RE: ESKOM EIA CONCERNS FOR THE PROPOSED NUCLEAR POWER STATION AND ASSOCIATED INFRASTRUCTURE (DEA Ref. No: 12/12/20/944)

ANTHONY REED – SUBMISSION ON DEIR FOR NUCLEAR-1: PROBLEMS WITH THE EIA'S PROCEDURAL ISSUES

Figure 4-7: Daily electricity demand patterns (Eskom 2009)

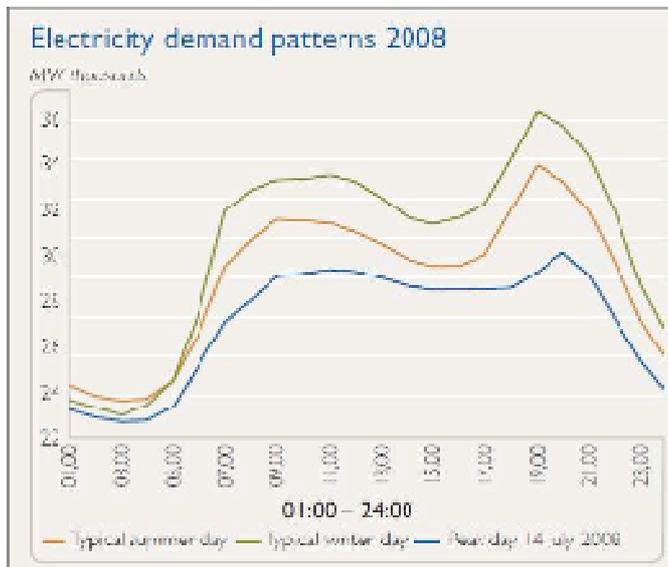
- Address causes of peak (seems a lot of domestic on top of background)
- Shift peak use into base load times where spare capacity exists
- Explore different time zones in South Africa to shift peak (07.00-09.00 and 17.00-21.00). If it were possible to lengthen peak period and flatten peak requirement we would have more time to make correct decisions.

- The EIA use "peak" usage challenges as an argument for the building of a nuclear power station, which is described in the same paragraph as being required for improving base-load generation. *The EIA needs to place before the decision-maker the correct information.* If peak usage is the problem there are alternatives to address this issue that have not been adequately discussed. This renders the whole motivation for the need, invalid.
- Daytime base-load could be well assisted by solar, and this could include covering in to the evening peak, but the only comparison in the EIA is against coal. The omission of the solar option to increase day-time base-load is a critical omission from the EIA.

It has been made clear throughout the EIA process that the purpose of a nuclear power station is to supply base load electricity. The reference to peak demand in Chapter 1 of the EIR is to illustrate the fact that the reserve margin (the difference between supply and demand) is still unacceptably low and does not to provide security of supply at all times. South Africa needs both base load and peaking power stations to provide greater security of supply. Although peaking power stations may be sufficient to deal with a poor reserve margin in the short term, it is clear (with reference to Response 2), that additional base load generation is also necessary to deal with supply challenges. The introduction to Chapter 4 of the Revised Draft EIR is also clear in that it refers to the need to additional baseload generating capacity.

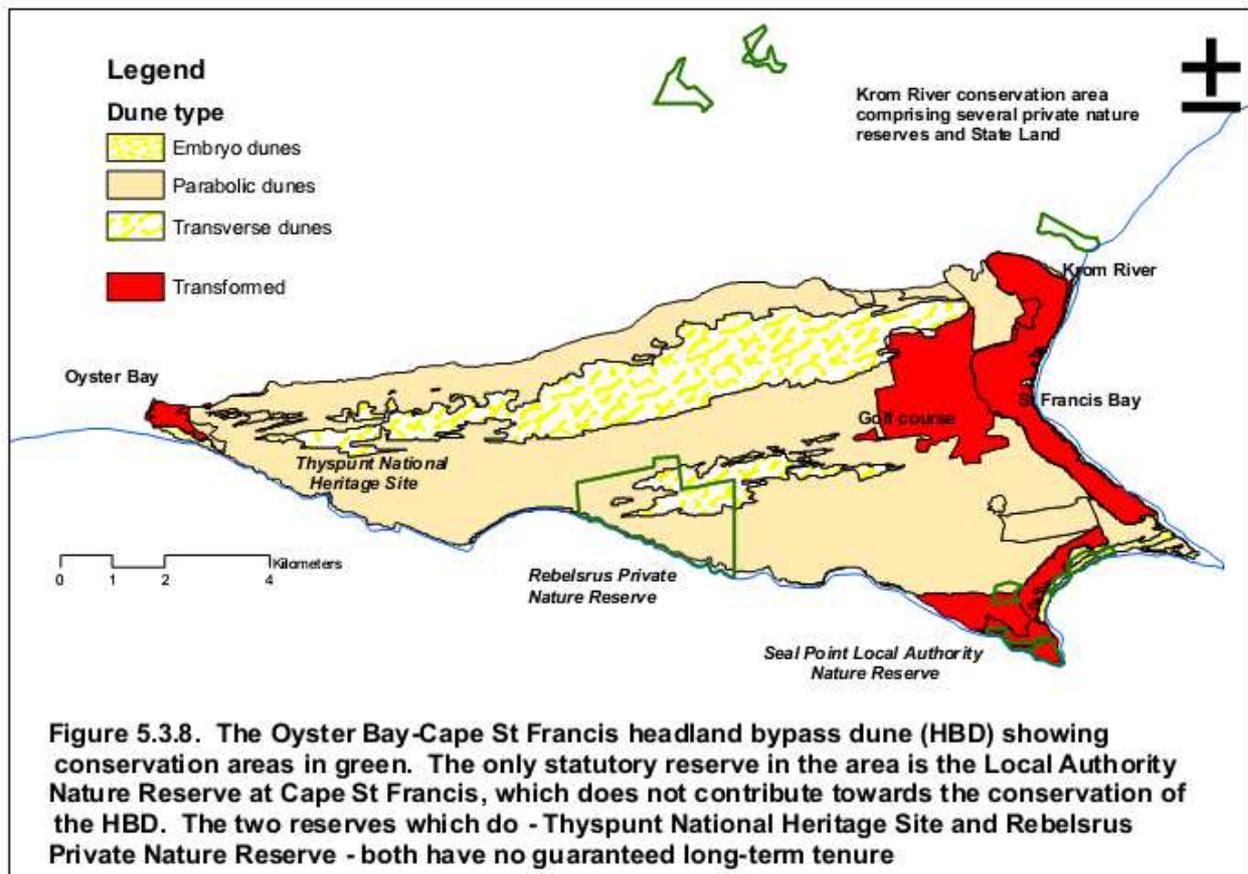
- The Rebelsrus combined property is the most significant easterly neighbour of the Eskom site and has been all but overlooked in this EIA report on the area. This is an oversight and the EIA report needs to include a comprehensive account of the Rebelsrus property, and only then can a valid conclusion be drawn on this.
- In considering the environmental impact therefore the report gives an exaggerated impact to any improved control on the Eskom land.

The contribution of the owners of Rebelsrus Private Nature Reserve to conservation of the natural heritage around the Thyspunt site is noted. The Botany and Dune Ecology Assessment (Appendix E11 of the Revised Draft EIR) considers the conservation areas in proximity to all three alternative sites. The figure below is from that specialist report.

As evident from the above figure, the specialist report acknowledges the conservation value of Rebelsrus Private Nature Reserve and Thyspunt Natural Heritage⁴ Site. The efforts of the Rebelsrus owners to conserve the land are to be commended. However, the conservation of the environment in Rebelsrus, in spite of the well-meaning and very valuable efforts of the landowners, has no long-term tenure as the land remains privately owned and has no statutory protection.
